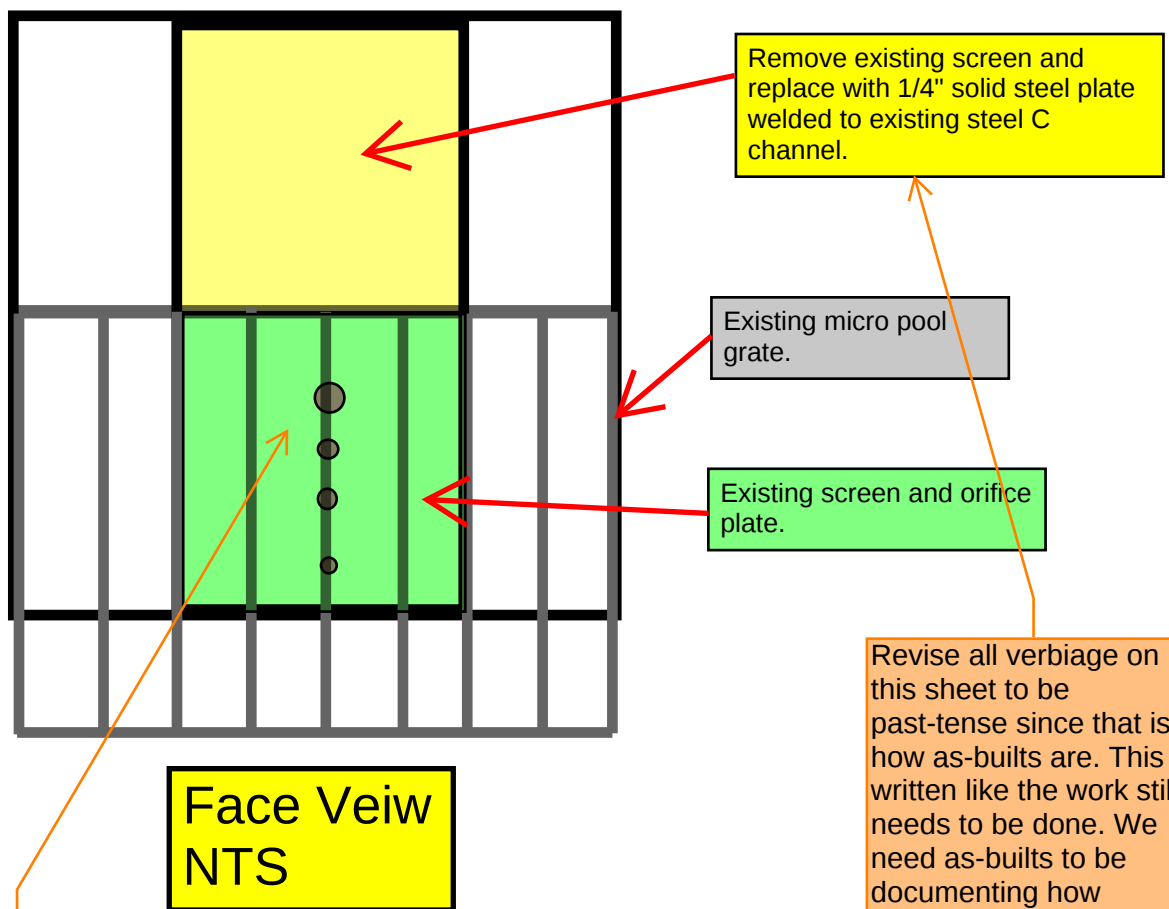
This should be attached to the As-Built Constrution Drawing PDF, not submitted separately as its own document. It's an as-built detail.

Include the "Engineering Record Drawings" label with your stamp on it. We need this to be certified as an as-built condition.

As a general comment, why was this the solution proposed? In our punchlist all we asked for was the gap at the top (in the horizontal plane) by covered up. The new plate/cover in the vertical plane (the yellow area below) was definitely not requested or necessary and will mess with the intended hydraulic functionality of the pond.

For future reference: this type of modification should have been sent to the County for review before the contractor was instructed to install it, to avoid misinterpretations of our punchlist items.

Review 2 update: please call or email me to discuss this. We need this certified that it won't impact the desired hydraulics. In reality, it is really unacceptable and needs to be removed. But I am open to discussing it and/or meeting in the field if you want.

Revise all verbiage on this sheet to be past-tense since that is how as-builts are. This is written like the work still needs to be done. We need as-builts to be documenting how something was installed, not how it was requested to be built.

Since this drawing is not to scale, can you please check if any of the orifice holes are behind the yellow plate above.

Review 2 update: in the field it appeared that maybe an orifice hole or two were being blocked, so we really need this to be checked and notated on here.
